REVISED GRADING AND DRAINAGE PLAN

ERNIE PYLE
MIDDLE SCHOOL

30/95023.11\DWG\KCP1GRDA/2-19-97/KHK	
REVISION	DATE
1	2/14/97
REVISED GRADING, ADDED NOTES - "AS-CONSTRUCTED"	
DESCRIPTION	
KIT CARSON ELEMENTARY SCHOOL	
GYMNASIUM FACILITY	
REVISED PHASE I GRADING AND DRAINAGE PLAN	
LEEDSHILL - HERKENHOFF, INC.	
ALBUQUERQUE ENGINEERS ARCHITECTS SANTA FE	
LH PROJECT MANAGER SHEET	
C3A OF 4	
5

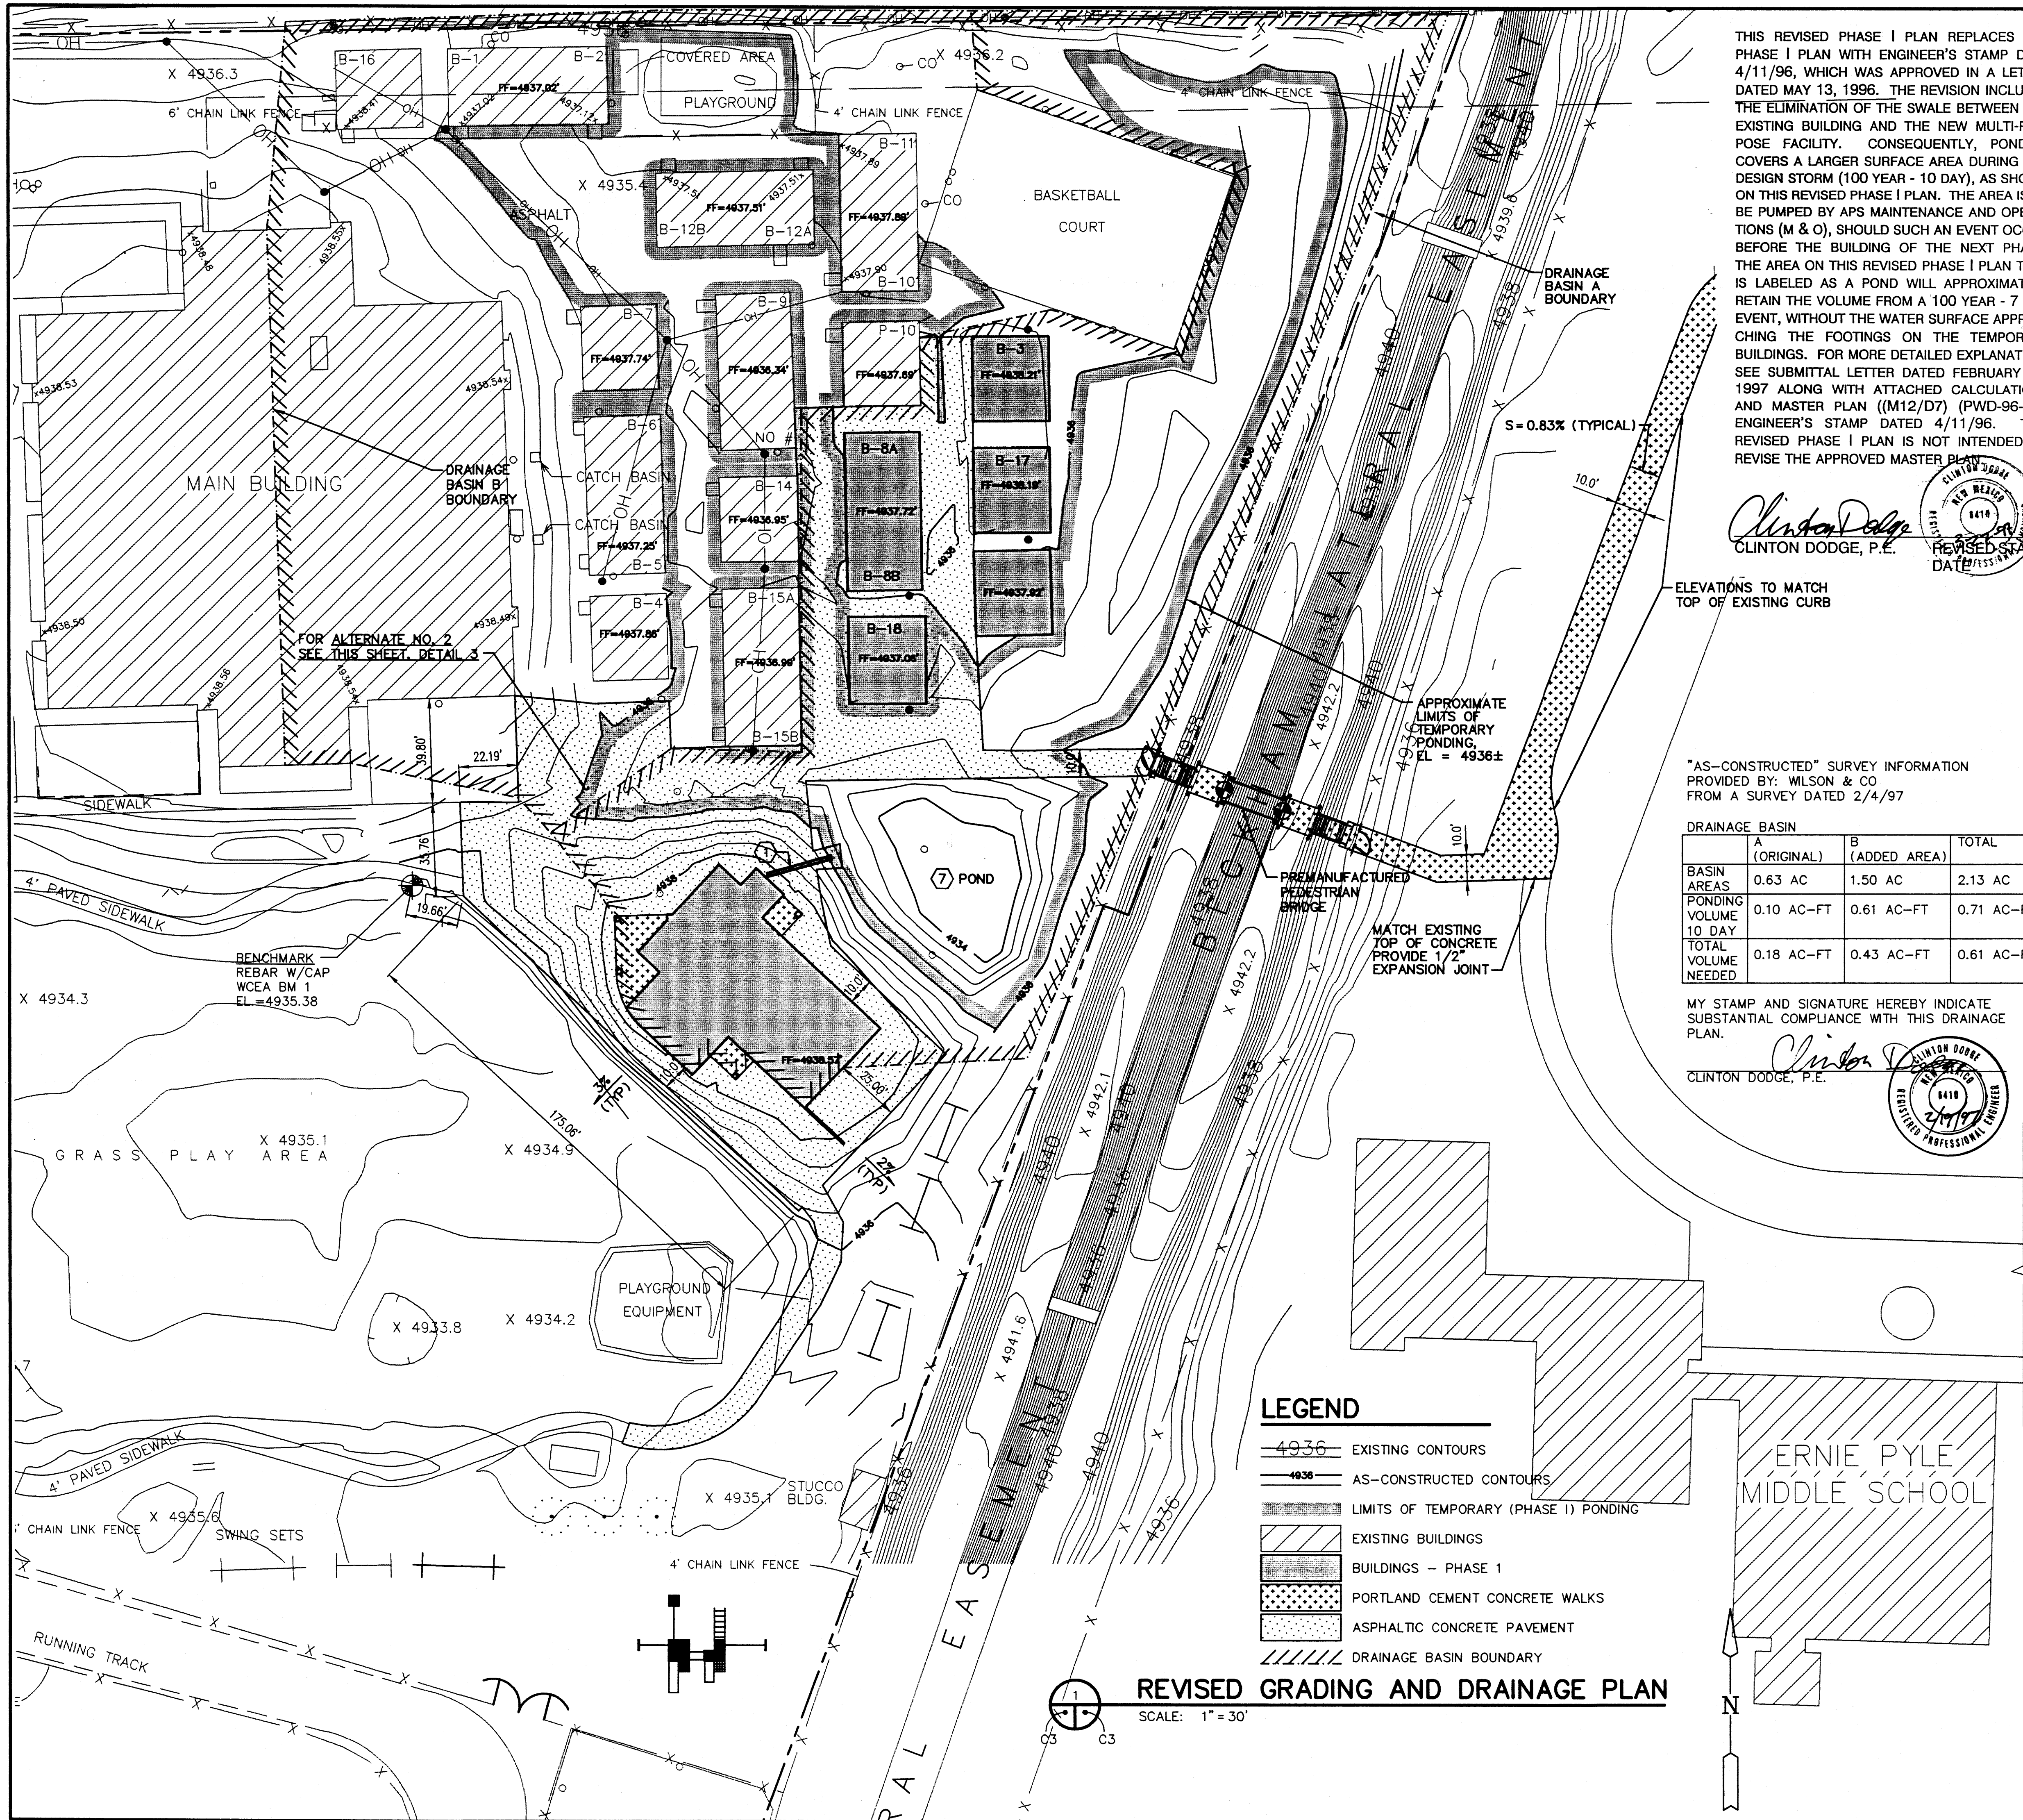
THIS REVISED PHASE I PLAN REPLACES THE PHASE I PLAN WITH ENGINEER'S STAMP DATE 4/11/96, WHICH WAS APPROVED IN A LETTER DATED MAY 13, 1996. THE REVISION INCLUDES THE ELIMINATION OF THE SWALE BETWEEN THE EXISTING BUILDING AND THE NEW MULTI-PURPOSE FACILITY. CONSEQUENTLY, PONDING COVERS A LARGER SURFACE AREA DURING THE DESIGN STORM (100 YEAR - 10 DAY), AS SHOWN ON THIS REVISED PHASE I PLAN. THE AREA IS TO BE PUMPED BY APS MAINTENANCE AND OPERATIONS (M & O), SHOULD SUCH AN EVENT OCCUR BEFORE THE BUILDING OF THE NEXT PHASE. THE AREA ON THIS REVISED PHASE I PLAN THAT IS LABELED AS A POND WILL APPROXIMATELY RETAIN THE VOLUME FROM A 100 YEAR - 7 DAY EVENT, WITHOUT THE WATER SURFACE APPROACHING THE FOOTINGS ON THE TEMPORARY BUILDINGS. FOR MORE DETAILED EXPLANATION, SEE SUBMITTAL LETTER DATED FEBRUARY 18, 1997 ALONG WITH ATTACHED CALCULATIONS AND MASTER PLAN ((M12/D7) (PWD-96-27), ENGINEER'S STAMP DATED 4/11/96. THIS REVISED PHASE I PLAN IS NOT INTENDED TO REVISE THE APPROVED MASTER PLAN.

REVISED GRADING AND DRAINAGE PLAN

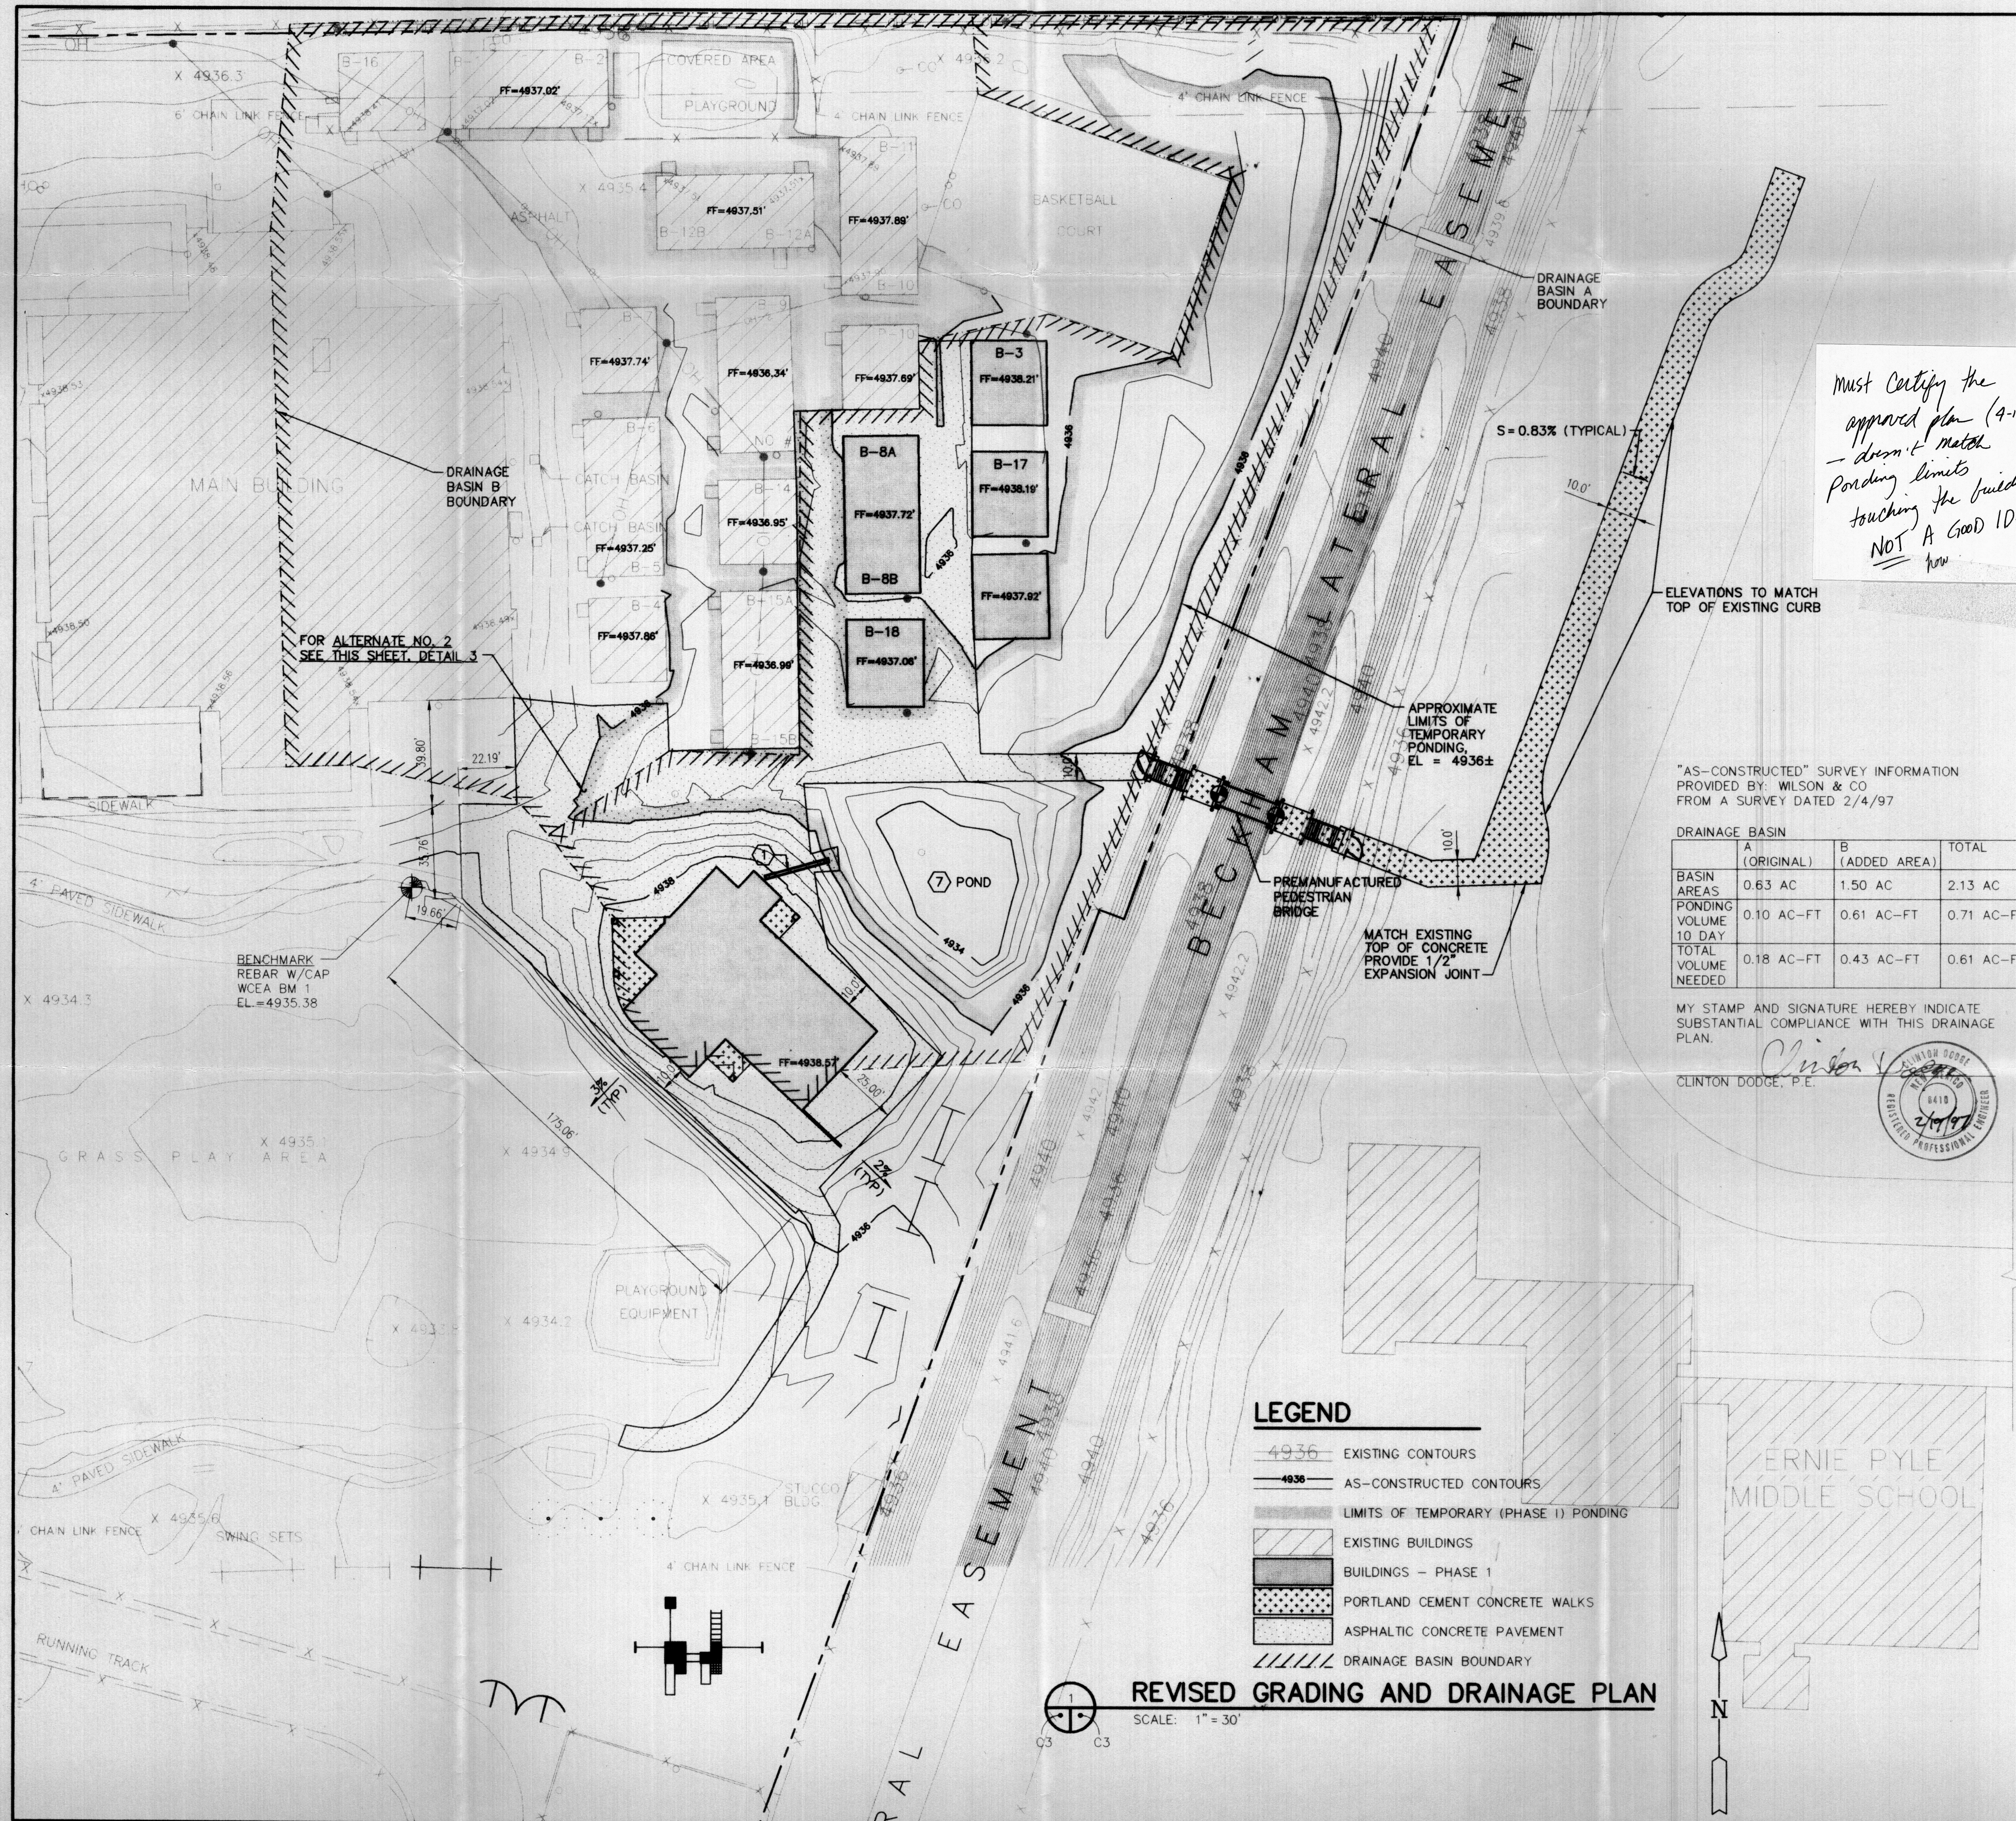
1	2/14/97	REVISED GRADING, ADDED NOTES - "AS-CONSTRUCTED"
REVISION	DATE	DESCRIPTION
KIT CARSON ELEMENTARY SCHOOL		
GYMNASIUM FACILITY		
REVISED PHASE I GRADING AND DRAINAGE PLAN		
QA RELEASE CD	DESIGN BY KJ	CHECKED BY CD
DRAWN BY KHK	SCALE 1" = 30'	DATE MARCH 96
LEEDSHILL - HERKENHOFF, INC.	ENGINEERS	ARCHITECTS
ALBUQUERQUE	SANTA FE	DATE MARCH 96
LH PROJECT MANAGER	SHEET	SEQUENCE NO.
C3A OF 4		5
